## 92 versus 34 - Height

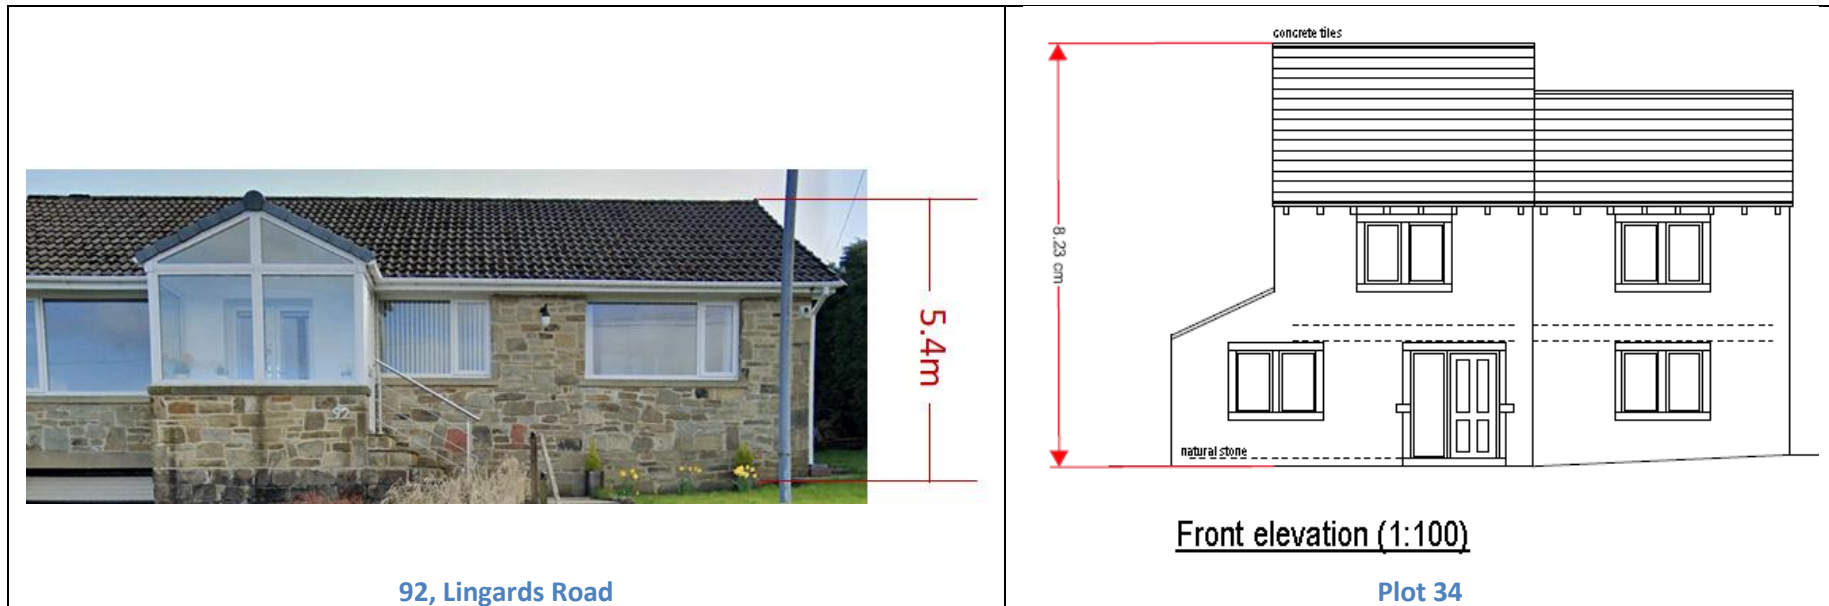
The image on the left (92), below, shows an existing dwelling, which typifies the style of bungalows seen opposite the site.

The image on the right, below, shows the proposed dwelling for plot 34, which would stand opposite 92, with the two elevations facing each other.

Where 92 stands 5.4m tall, plot 34 would stand 8.23m tall.

That means **plot 34 would be almost 3m taller.**

That means **plot 34 would be more dominant.**

## 82 versus 37 - Height

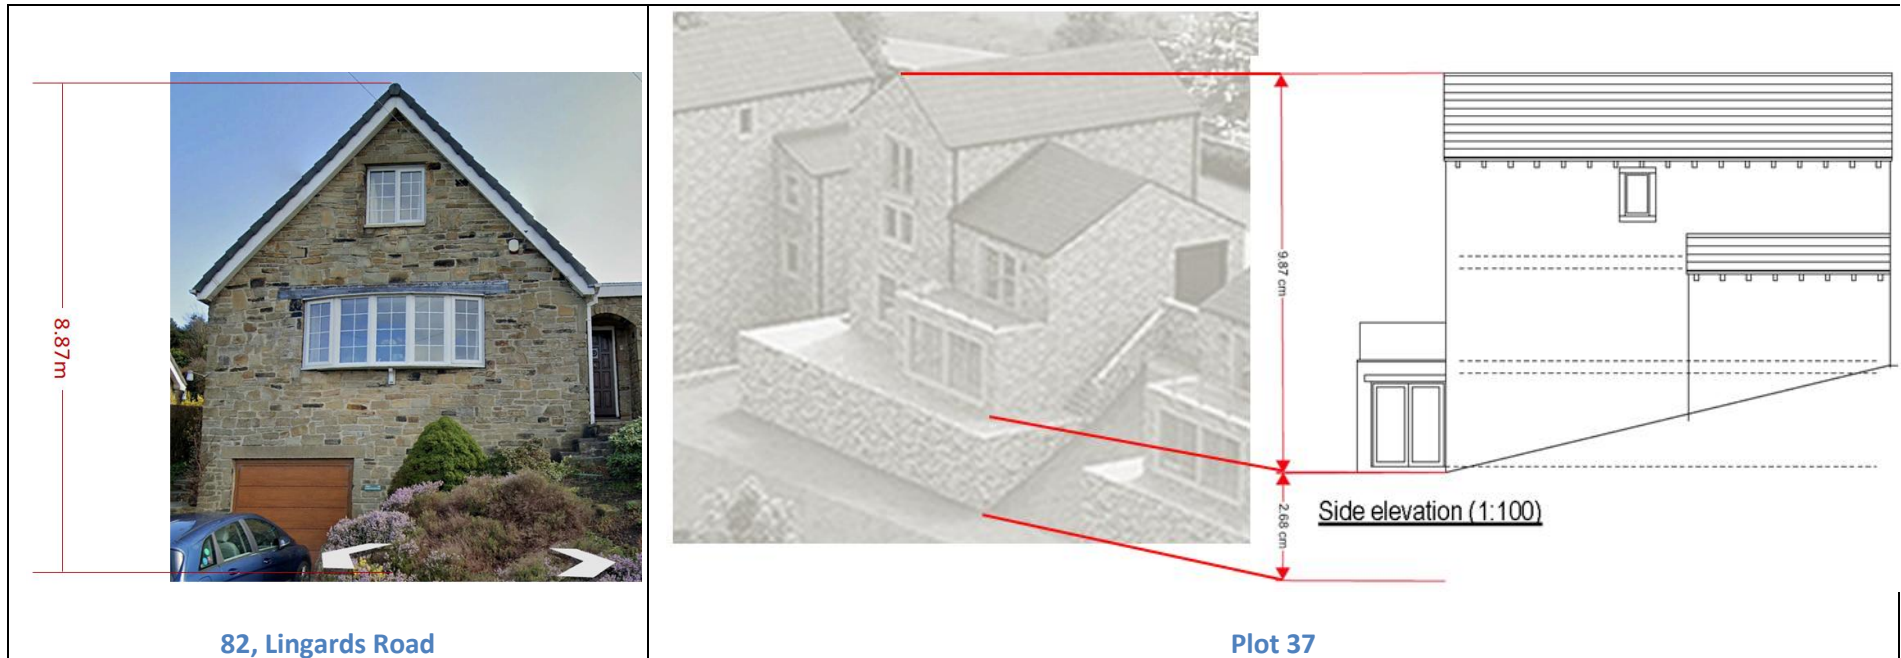
The image on the left (82), below, shows an existing dwelling, which typifies a number of properties seen opposite the site.

Whereas, the image on the right, below, shows the proposed dwelling for plot 37, which would stand opposite 82, with the two front elevations facing each other.

At its highest point, 82 stands 8.87m tall. Whereas, plot 37 would stand 12.55m tall.

Even though both could, arguably, be considered 3 storey, **plot 37 would be 3.68m taller.**

That means **plot 37 would be more dominant.**

## 82 versus 37 - Width

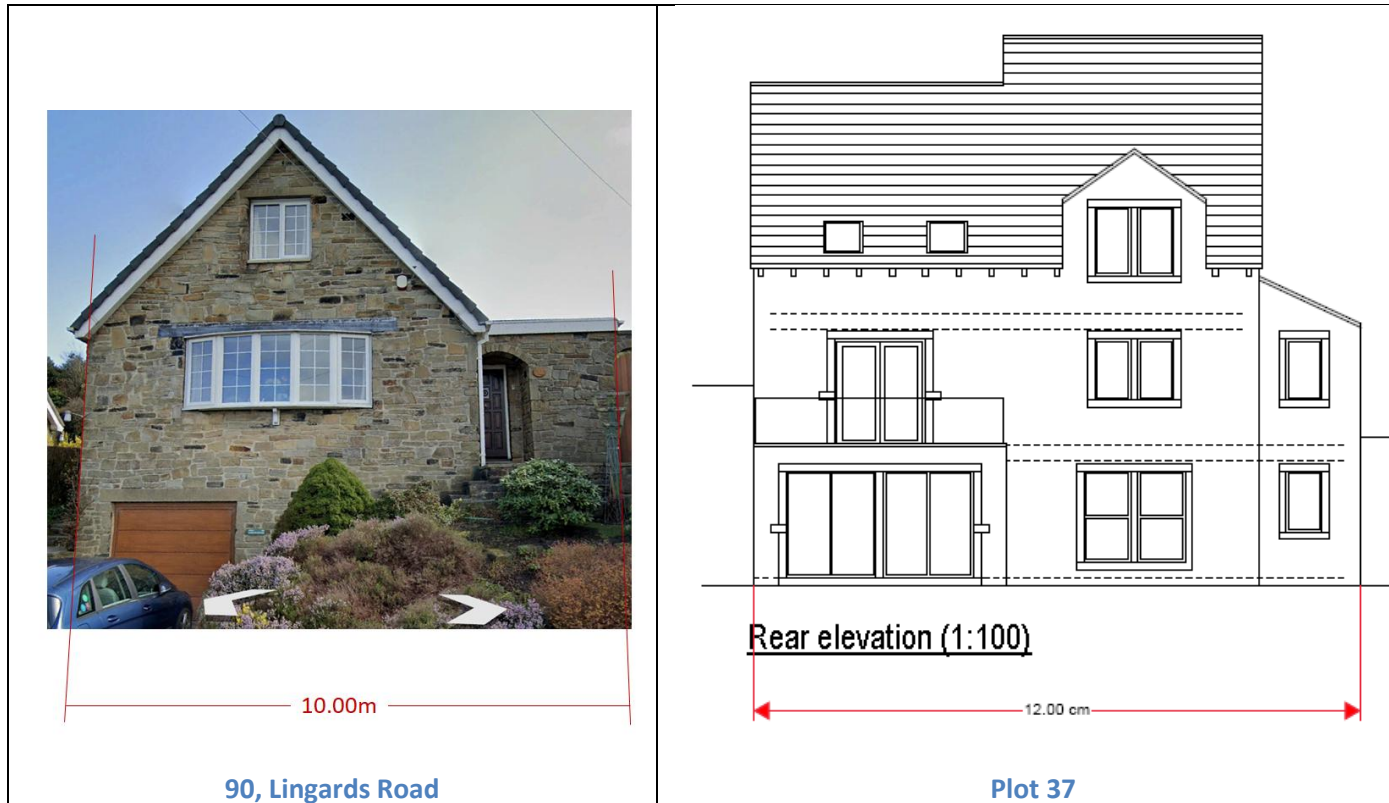
The image on the left (82), below, shows an existing dwelling.

The image on the right, below, shows the proposed dwelling for plot 43, which would stand opposite 82.

The front elevation of 82 is 10m wide.

The front elevation of plot 37 would be 12m wide.

That means **plot 37 would be 2m wider.**

That means plot 37 would be more dominant.

## 82 versus 37 - Floor space

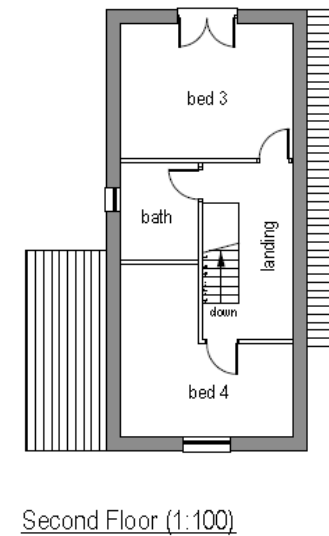
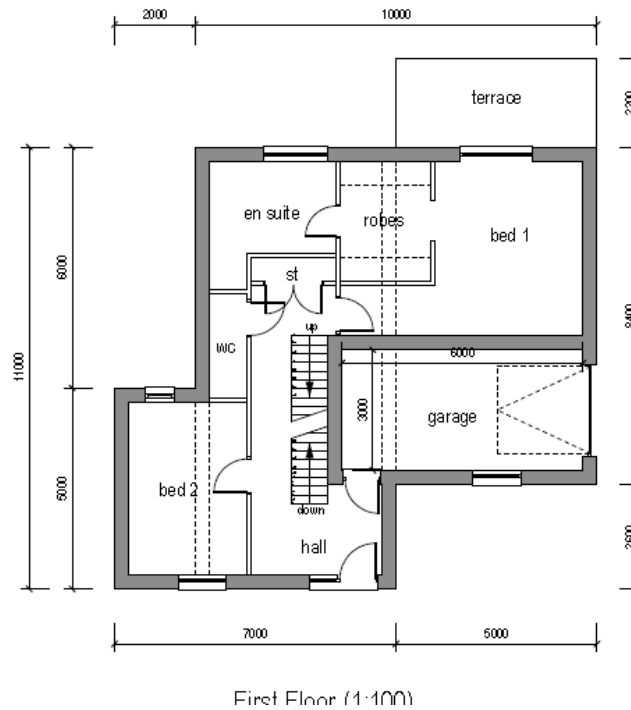
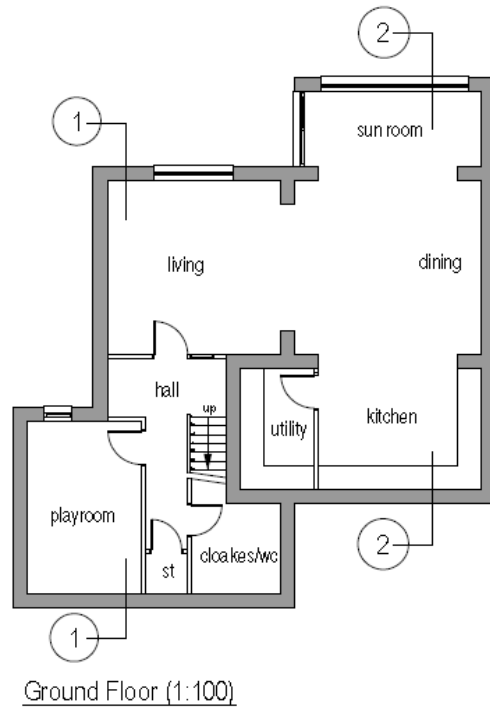
For plot 37, the total floor space has been calculated to be 207.64m<sup>2</sup>. This excludes the garage.

For 84, the total floor space has been calculated to be 93.65m<sup>2</sup>. This too excludes the garage.

207.64m<sup>2</sup> versus 93.65m<sup>2</sup> means plot 37 would be **221%** the size of 84, which is **huge**.

## 92 versus 34 - Floor space

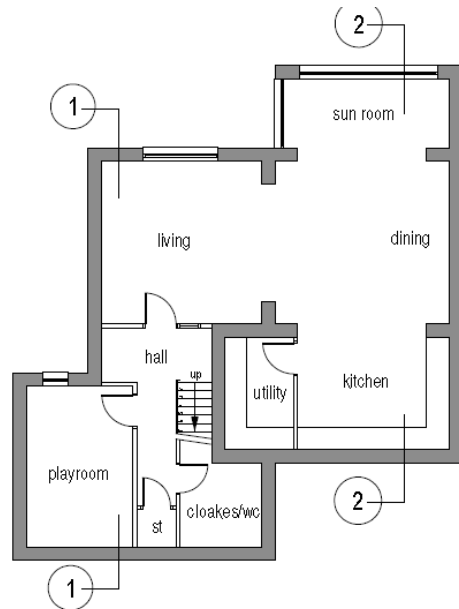
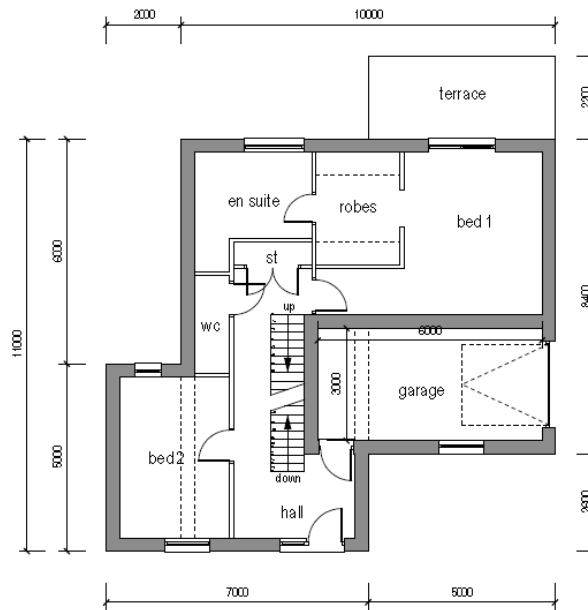
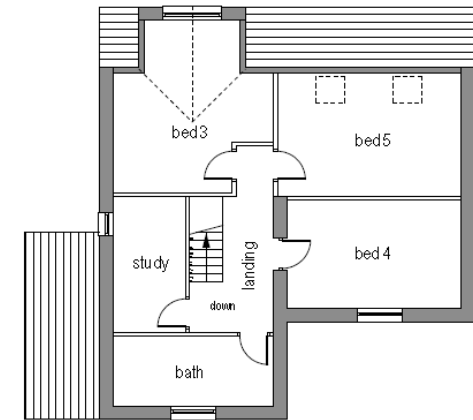
For plot 34, the total floor space has been calculated to be 237.67m<sup>2</sup>. This excludes the garage.

For 92, the total floor space has been calculated to be 97.08m<sup>2</sup>. This too excludes the garage.

237.67m<sup>2</sup> versus 97.08m<sup>2</sup> means plot 34 would be **245%** the size of 92, which is **huge**.
